Errata for
Fundamentals of Fiber Orientation

Charles L. Tucker III
Department of Mechanical Science and Engineering
University of Illinois at Urbana-Champaign
1206 W. Green St.
Urbana, IL 61801

February 23, 2025

Fig. 8.6(c) Stiffness, 40 wt.% long glass fiber/PP

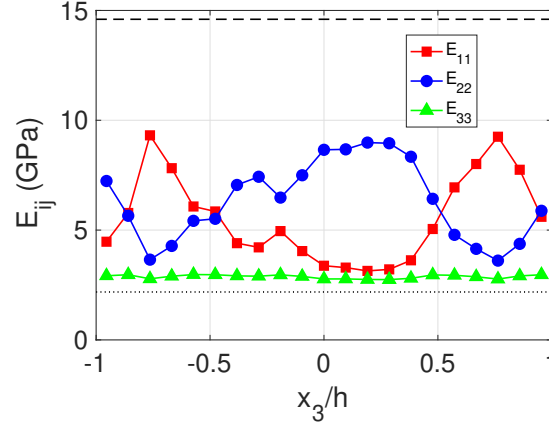
The example calculation in Section 8.4.5 for the stiffness of a layered structure states that the long glass fiber/PP composite has 40% by weight of fibers. However, the calculations in Fig. 8.6(c) and Table 8.4 actually used 30% by weight. The correct figure should look like this:

The correct table should read:

Table 8.4 Predicted tensile and flexural moduli for the two injection molded samples in Fig. 8.6.

E_{11} (GPa)	E_{22} (GPa)
30 wt.% short glass fiber/PC		
Tensile	8.04	4.02
Flexural	8.51	3.75
40 wt.% long glass fiber/PP		
Tensile	5.59	6.38
Flexural	6.58	5.42
